MODELS 1500, 1550, 1500A, AND 1550A TURN-TABLE MOTOR REPLACEMENT.

EARLIER TURNTABLE MOTOR PART NO. 56454 FIGURE -!

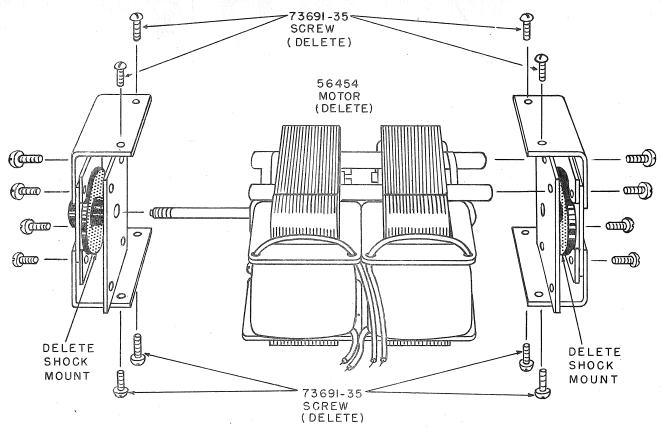
- 1. Turn-table motors used on later models 1500A and 1550A are of the optional type (Part No. 56455). Due to the fact that the earlier motors (Part No. 56454) are no longer available, any orders received for turn-table motors will be filled with Part No. 56455.
- 2. For this later motor to mount accurately in the mounting casting (Part No. 56874), it will be necessary to delete parts marked in Fig. 1 and in their place use the following parts:

4-49153 Connector 2-56843 Shock Mount 8-73691-34 Screw, Sem 8-32 x ½" 6-73607-5 Lock Washer 6-73601-6 Nut -6-32 Hex

- 3. The assembly will be accomplished as shown in Fig. 2
- 4. The parts designated in paragraph 2 will automatically be included with Part 56455 Turn-table Motor when designated for a Model 1500 or 1550, 1500A or 1550A phonograph. This practice will continue until otherwise instructed by the distributor.
- 5. Part No. 54439-1 Bearing, upper is now available for replacement of turn-table motor (Part No. 56454) upper bearings, and Part No. 54439-2 bearing, lower is available for replacement of the lower bearing. These bearings may also be used on Models 1600 and 1400.
